Avnet MicroZed 7020
Revision G Errata
V1.0
26 June 2018

3.1 PUDC_B Pull-up Populated with 0-ohm instead of 1K-ohm

Figure 2 – JT4 Pull-up Connected to PUDC_B, JX1_LVDS_2_P, and JX1-Pin17

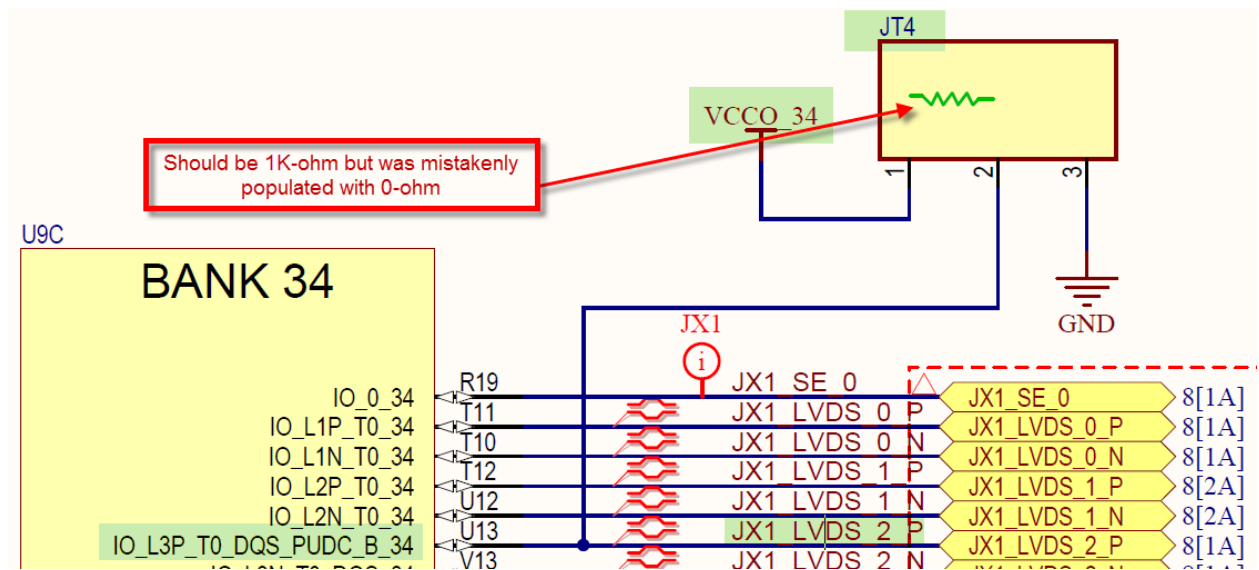
On MicroZed, the PUDC_B signal is in Bank 34 of the Zynq-7000, Pin U13 on component U9C on Sheet 6 of the schematic document. This pin is tied to schematic signal JX1_LVDS_2_P, which is also tied to resistor jumper JT4 and MicroHeader JX1 Pin 17.

Resistor jumper JT4 is a 3-pad component that allows an 0402 resistor to be placed either in the 1-2 position or the 2-3 position. By default, this was supposed to be populated with a 1K-ohm resistor in the 1-2 position. Unfortunately this was mistakenly populated with a 0-ohm resistor, thus shorting JX1_LVDS_2_P to power supply VCCO_34. This effectively disables PUDC, but it also makes this I/O unusable.

Figure 3 – JT4 on MicroZed

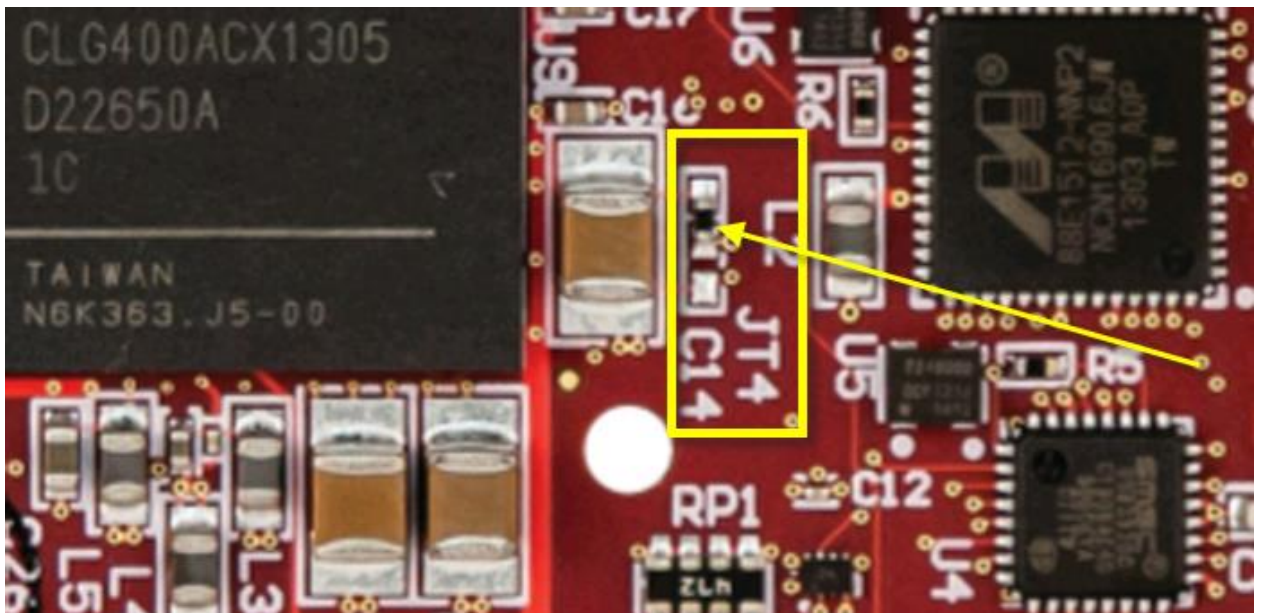
1. Remove the resistor at position 1-2 of JT4.

2. Solder a new, 0402 1K-ohm resistor to position 1-2 of JT4. A few suggestions are listed below.
 - a. Panasonic Electronic Components ERJ-2RKF1001X
 - b. Yageo AC0402FR-071KL
 - c. Yageo RC0402FR-071KL

Figure 4 – Repaired MicroZed Rev G Board

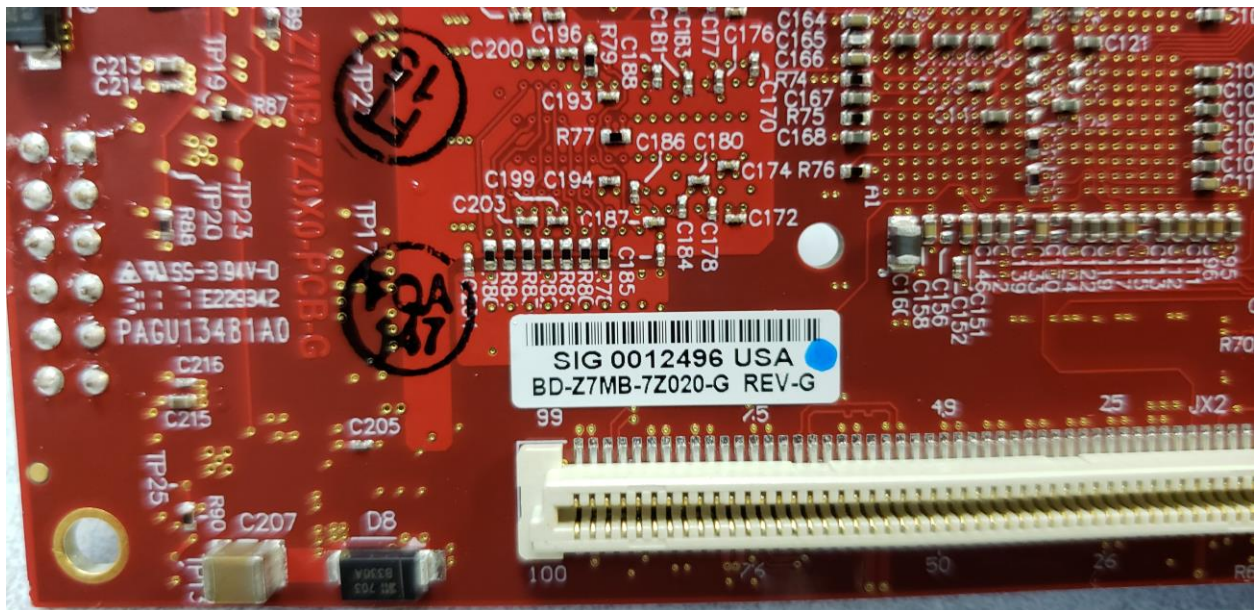
A repaired Revision G board that has this workaround in place will be identified with a blue mark on the bar code label as shown below:
